# Columbia County West End Flood Mitigation Study

## ADDENDUM NO. 2

### 2-Dimensional Hydraulic Analysis Final Recommendations

Verdantas Response to PennDOT Comments  
10.16.25

## 5. Structures and Hydraulics

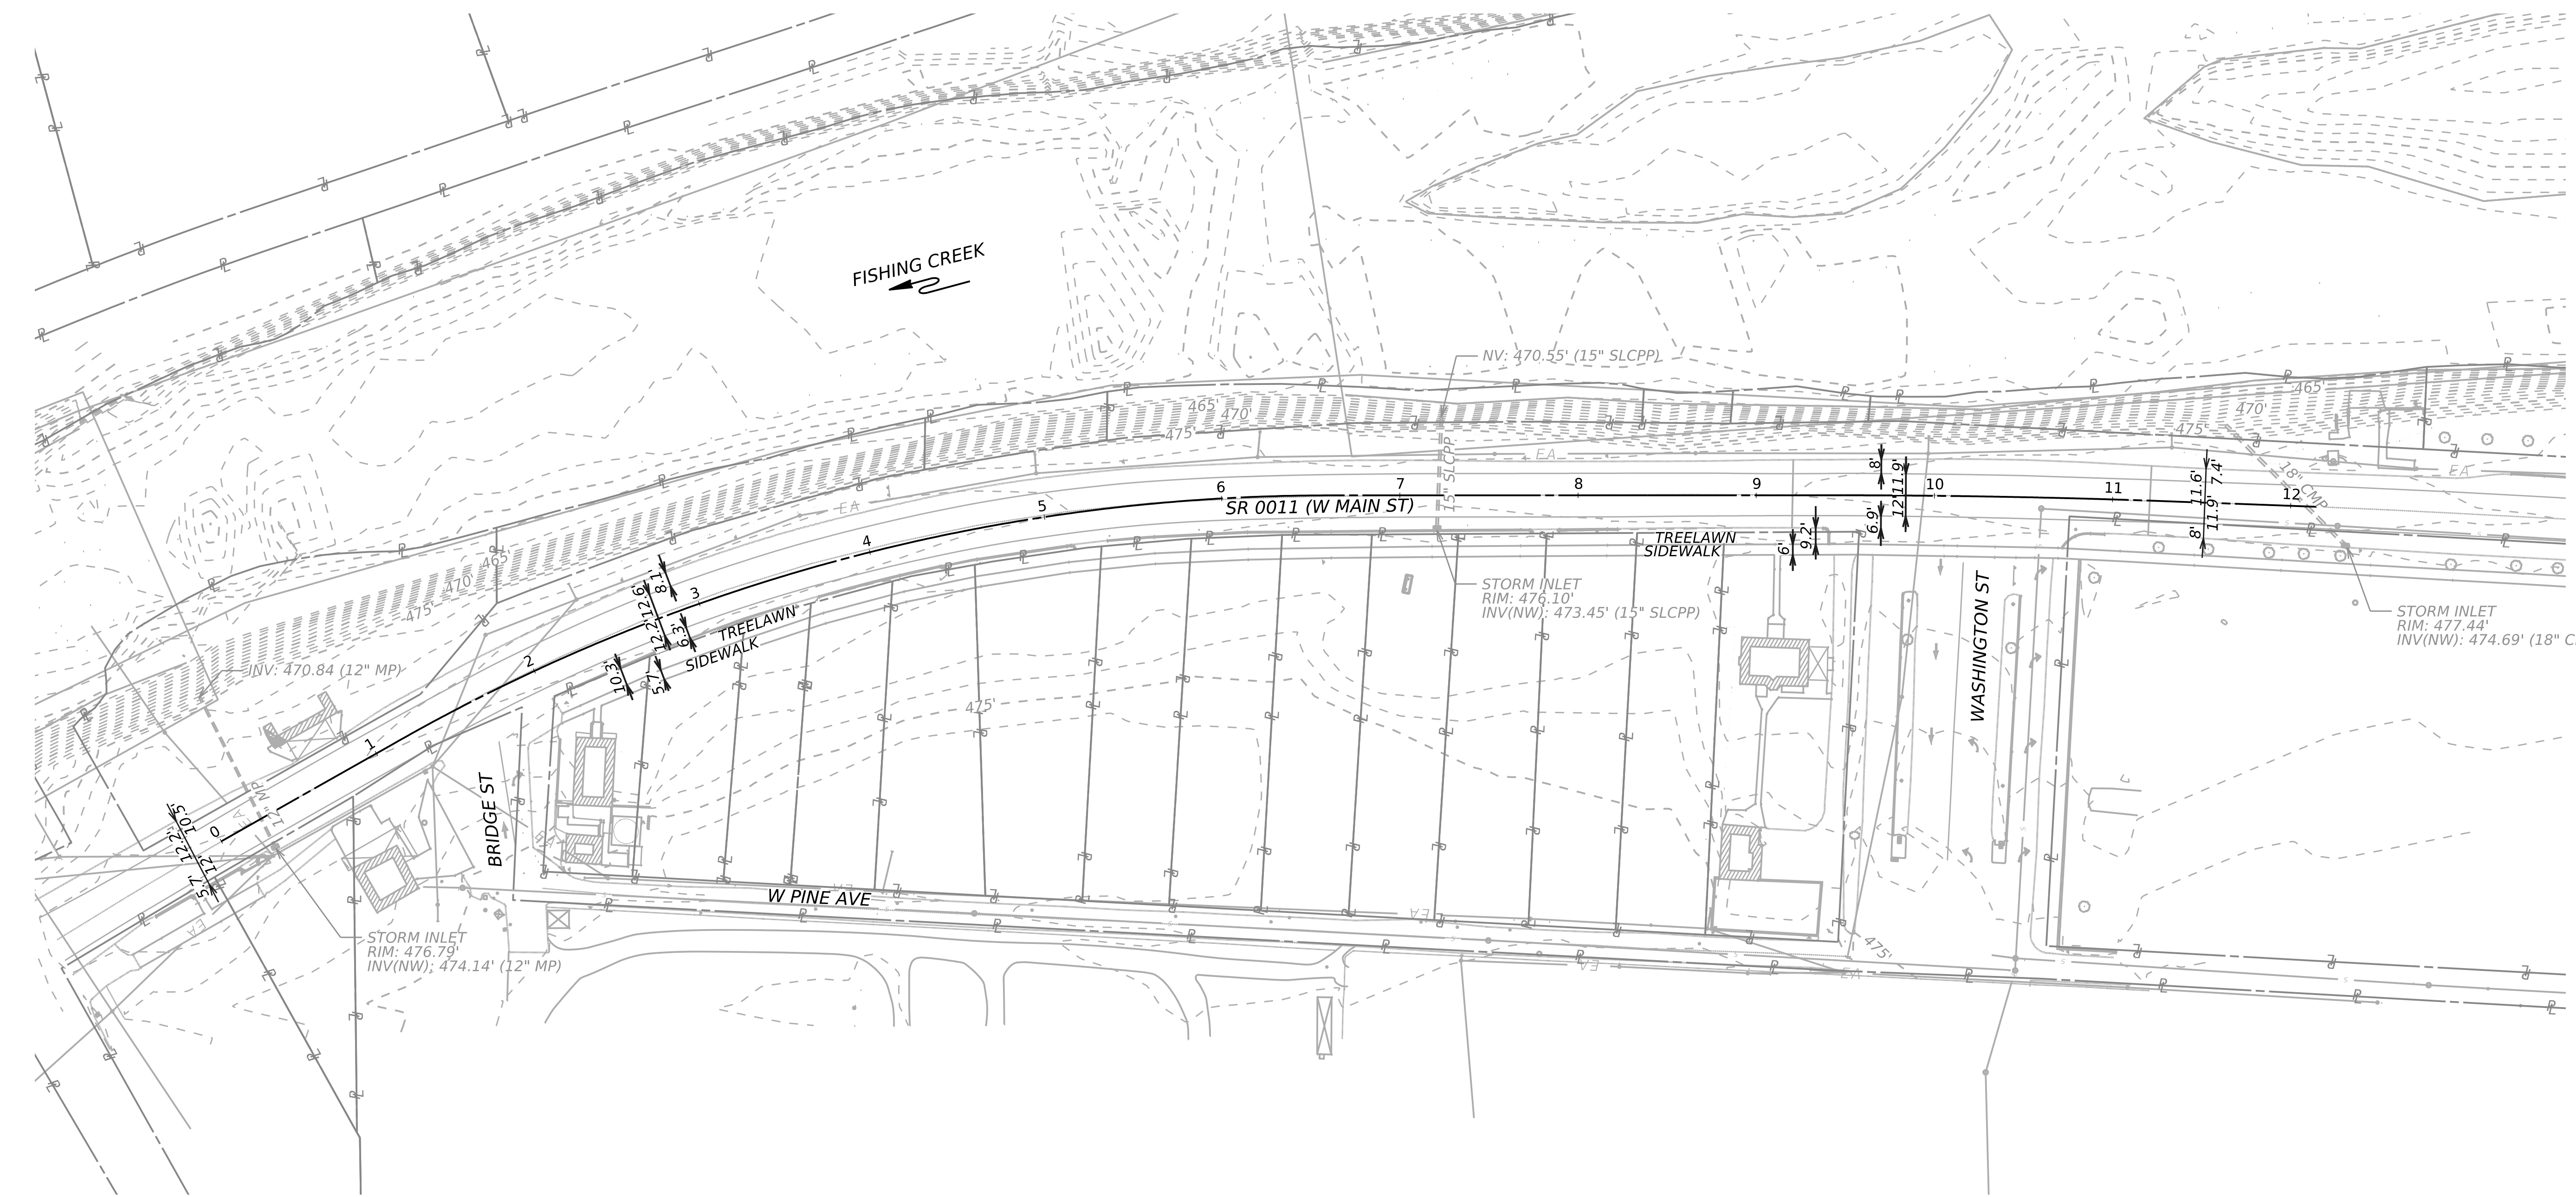
- Provide a plan for the closure structure and include structural calculations.
- A foundation report may be required depending on the structure type.

- Sheet pile design information should be included.
  - Anticipated depth of retaining walls
  - Potential utility impacts
  - Need for housing and vibration monitoring potentially with the location being close to any homes.

- All submissions must be signed and sealed by a Pennsylvania-licensed PE.
  - ✓ ***The foundation report and design calculations will be submitted for review and comment. The report will include recommendations for vibration monitoring during construction.***

DISTRICT	COUNTY	ROUTE	SECTION	SHEET
3-0	COLUMBIA			2 OF 8
REVISION NUMBER	REVISIONS			DATE BY

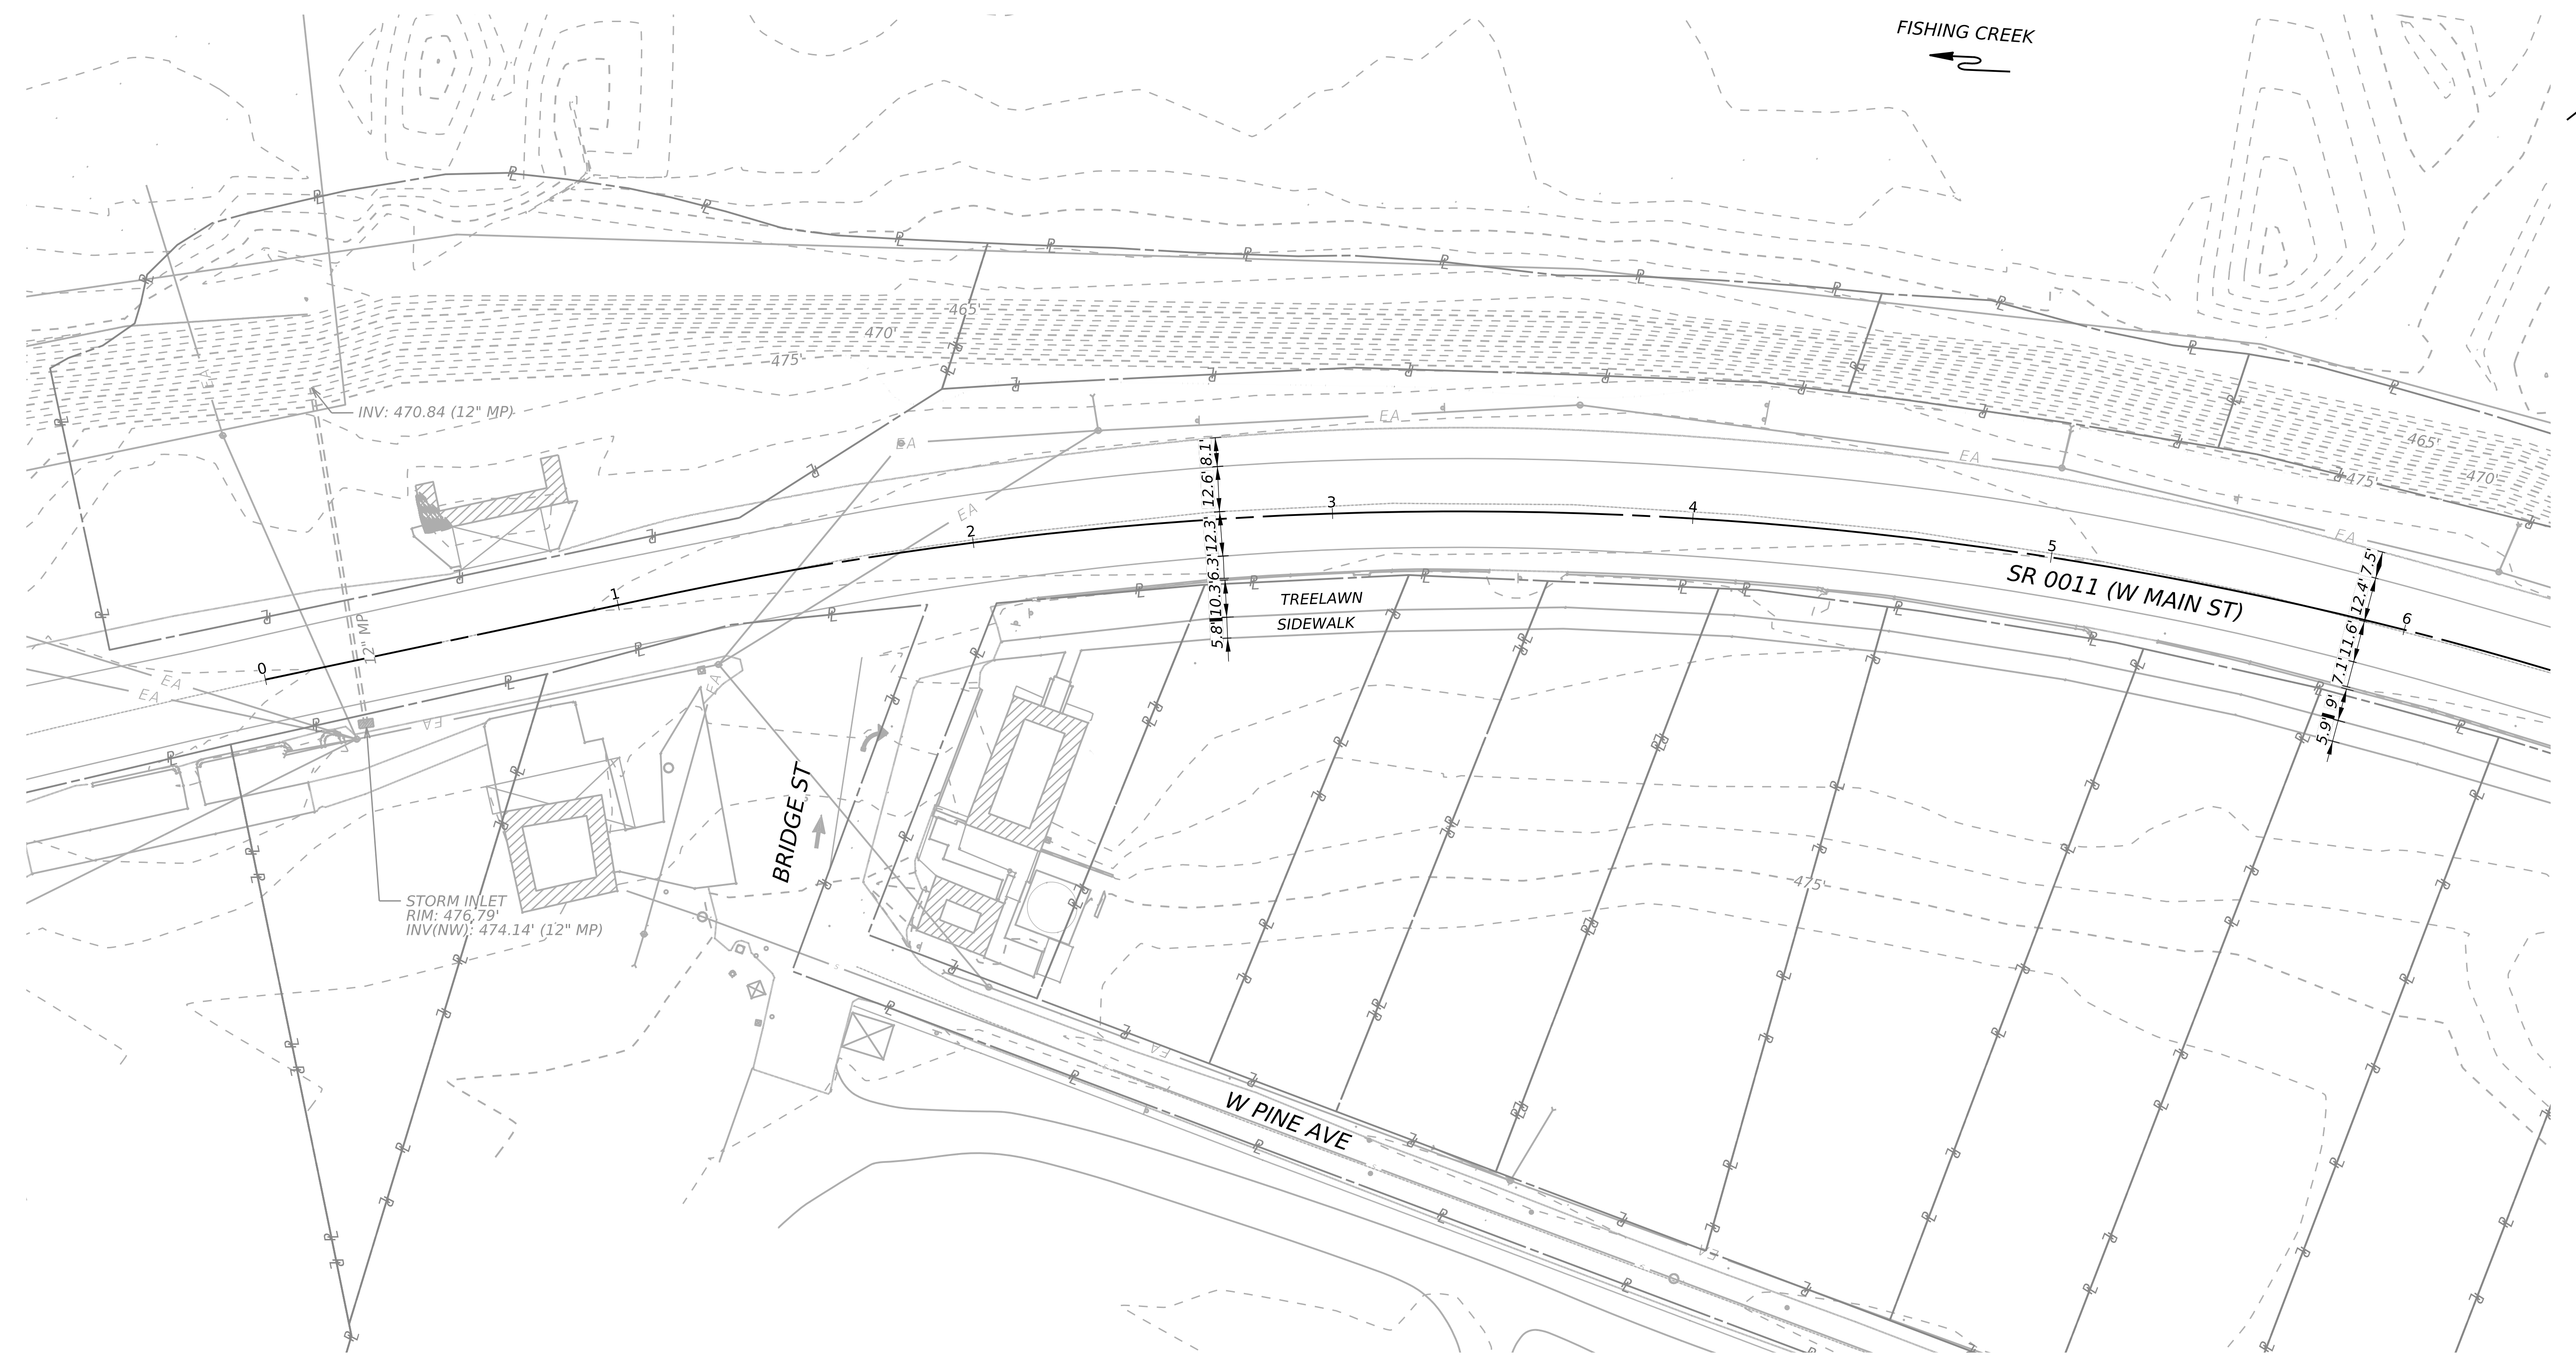
- Explain the purpose of the "Concrete Curb (No Reveal)" shown on the typical section (Sheet 2).
- Verify the low point elevations noted in the typical section and profile (475.6 vs 476.3).

- Note 2 on the typical section ("Vary shoulder low point for drainage") is not standard practice; please clarify intent.
- The flat profile will likely cause ponding along the curb line and does not align with design manual guidance.

- Verify the low point elevations noted in the typical section and profile (475.6 vs 476.3).
  - ✓ ***The elevation 476.3 is the existing low point at the edge of shoulder on the Fairgrounds side of SR 0011.***

- ✓ ***The elevation 475.6 is the proposed low point shown on the typical sections.***
- Note 2 on the typical section (“Vary shoulder low point for drainage”) is not standard practice; please clarify intent.
